REPORT OF USATECOM PROJECT NO 7D-3255-01 SERVICE TEST
OF CONTROLLER, DIFFERENTIAL PRESSURE, PIPELINE
PUMP UNIT (DA PROJECT NO 8M53-03-001-06)

SUBJECT: Report of USATECOM Project No. 7D-3255-01, Service
Test of Controller, Differential Pressure, Pipeline Pump
Unit (DA Project No. 8M53-03-001-06)

SUMMARY SHEET

USATECOM PROJ NO 7D-3255-01
PHOTO NO 63-11

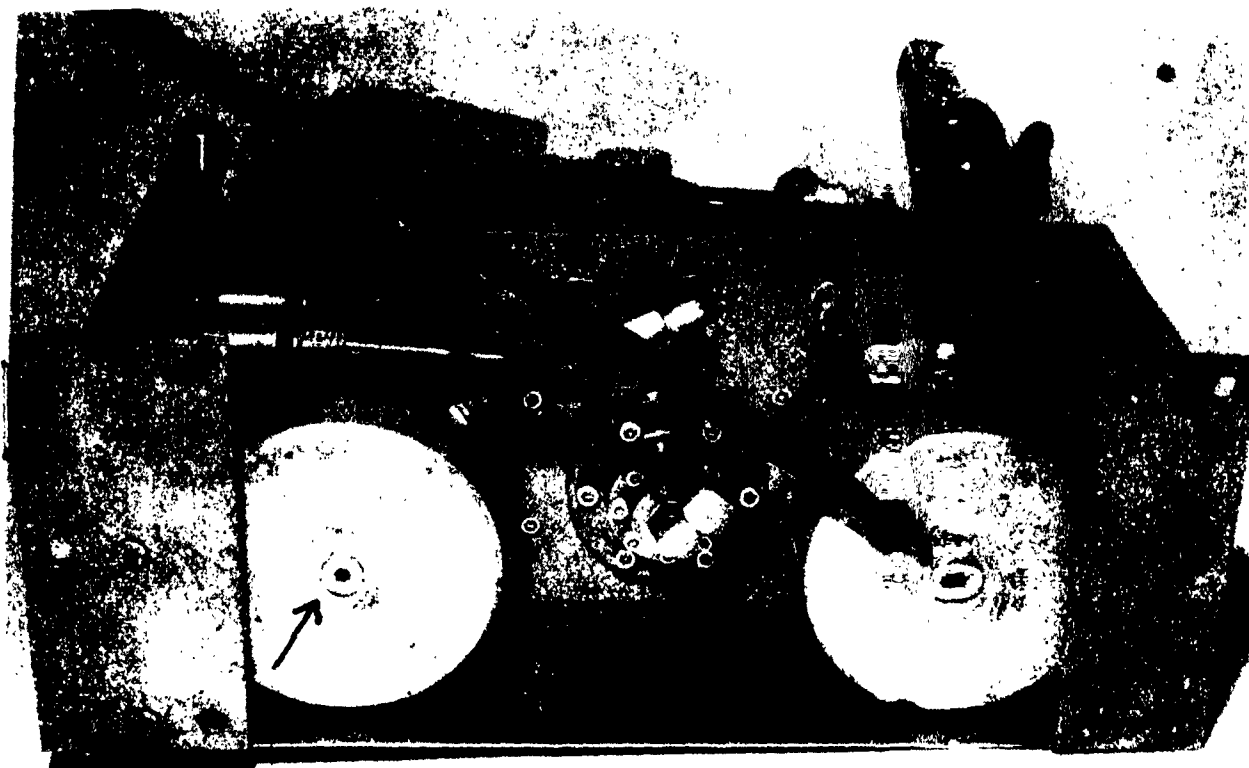
3. The spring-loaded check valves on the control units do not allow the fluid to flow freely from the reservoir.

| 11. The plug valve is easily broken off at the base during shipment of the control unit. | Brace the reservoir and plug valve assembly to the main body of the control unit or provide for removal during shipment. | See page C.2, annex C. |

1. PLUG VALVE. ARROW INDICATES POINT OF BREAKAGE.
2. SPRING-LOADED CHECK VALVES THAT OBSTRUCT FREE FLOW FROM RESERVOIR.

Replace the present check valves with non-spring-loaded type.

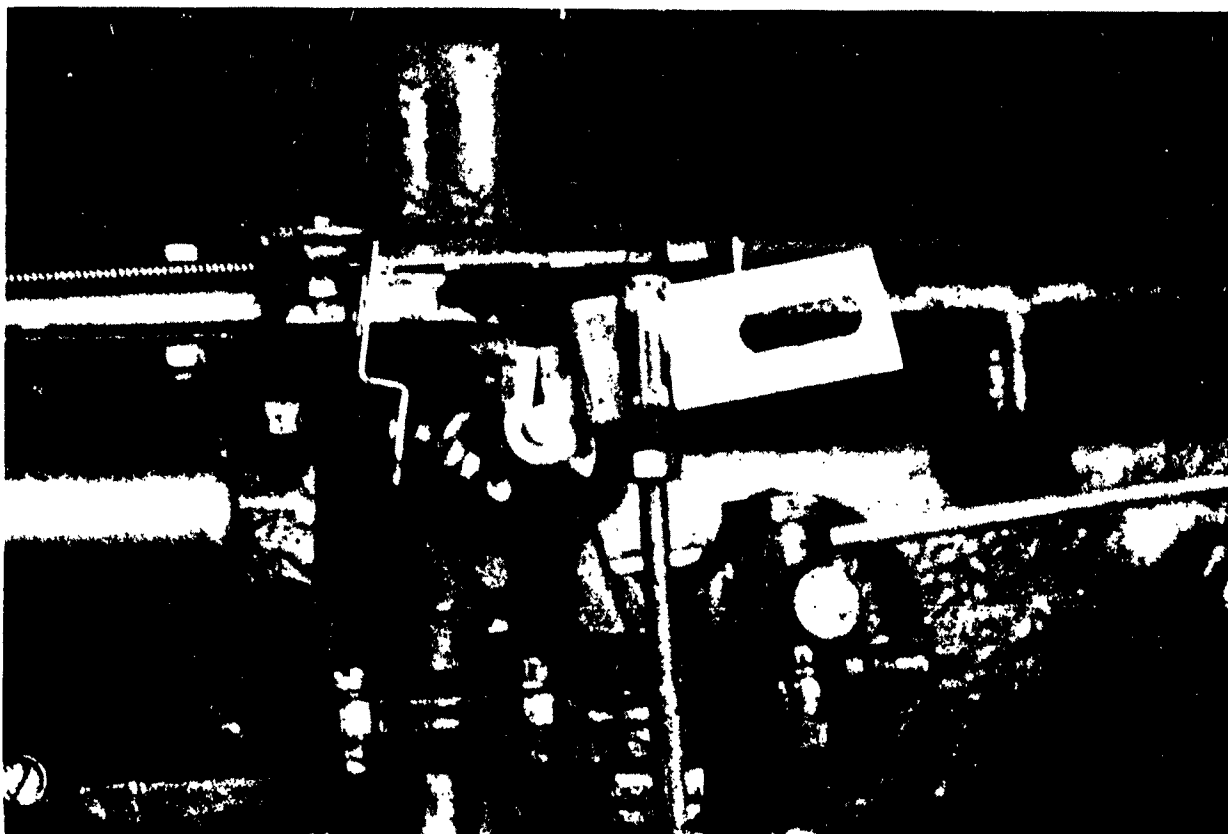
2. All control units leaked around the low suction pressure cutoff adjustment valve.

5. The springs and housing of the low and high pressure cutoff adjustment screws became rusted making adjustment difficult.

| 7. The existing fast-idle stop is too long and causes the engine to idle at approximately 1,400 rpm during warmup period. | Shorten the fast-idle stop to allow the engine to idle at approximately 900 rpm. | See item K, page C.7, annex C. |

Redesign the low suction pressure cutoff assembly to eliminate this condition.

Make the springs and housings from a rust resistant material.

TEST ITEM MOUNTED ON PUMP. NOTE EXCESSIVE LENGTH OF
HANDLE. (ARROW)

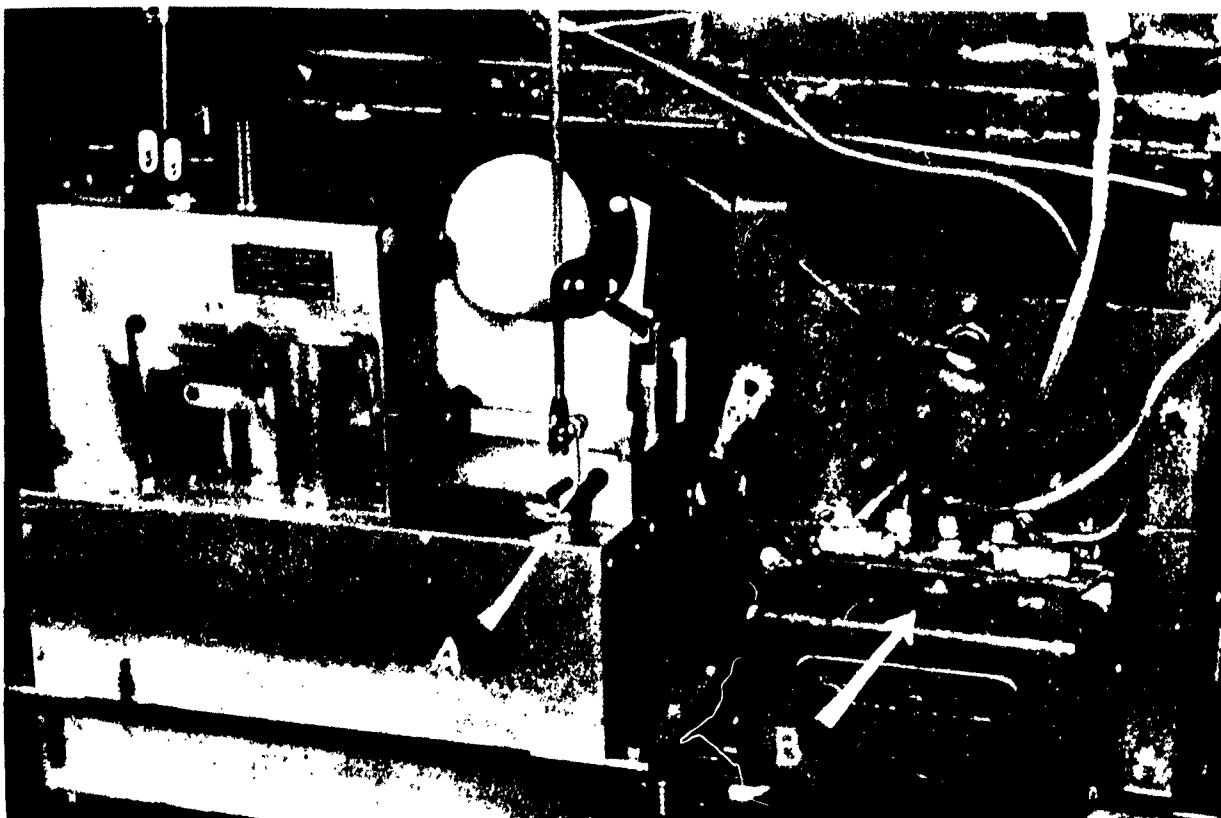
j. The hydraulic hand pump handle was too long and hit the side panel of the engine. (See item 8, annex B.)

| 8. The hydraulic hand pump handle is too long and hits the side panel of engine. | Shorten the handle so as not to extend beyond the side of the control unit. | See page C.10, annex C. |

MOUNTING OF TEST ITEM ON PEERLESS MANUFACTURING COMPANY
PUMP NECESSITATED MOVING VOLTAGE REGULATOR FROM POINT "A"
TO POINT "B".

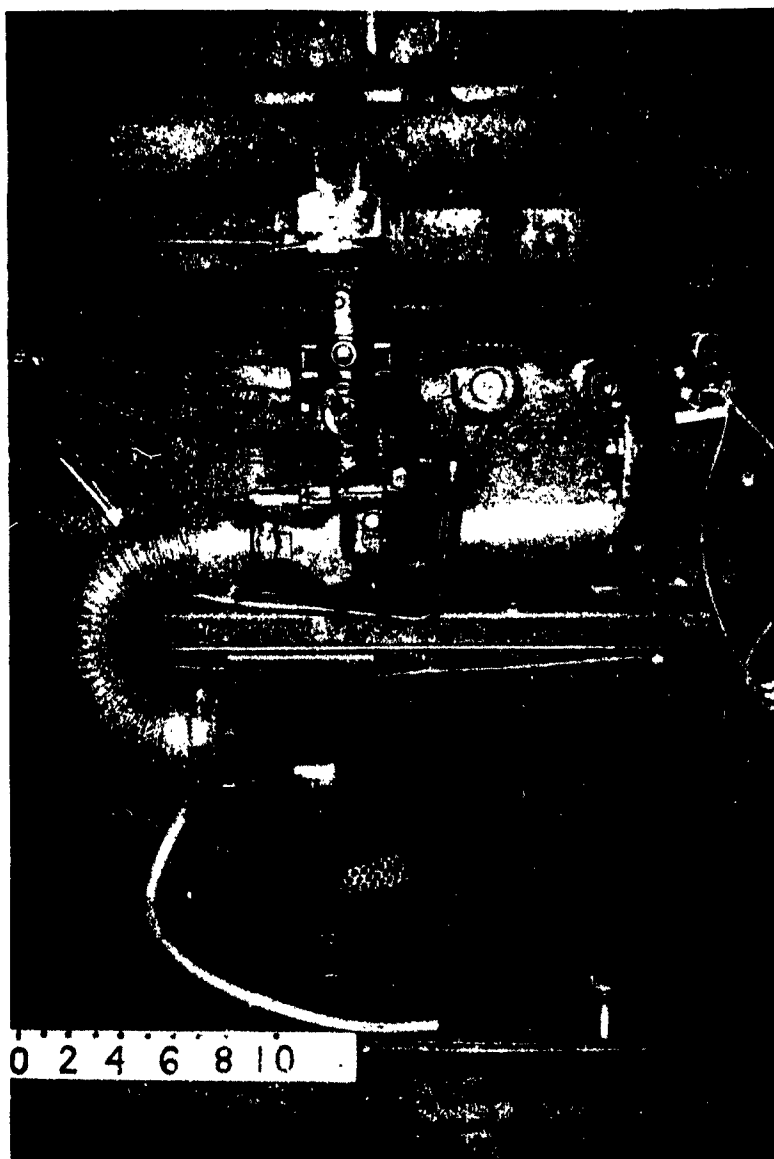
1. PURPOSE. To determine the compatibility of the test item with related equipment.
2. METHOD. The test items were mounted on pumps manufactured by Peerless Pump Company and Consolidated Manufacturing Company, both standard items in the supply system. Difficulties encountered and modifications required were noted.
3. RESULTS.
 - a. On the pump units fabricated by Peerless Pump Company, the voltage regulator and the reverse current overload switch had to be relocated to allow installation of the test item. (See page C.11, annex C.)
 - b. On the pump units fabricated by Consolidated Manufacturing Company the oil bath type air cleaner had to be relocated to allow installation of the control unit. (See page C.12, annex C.)
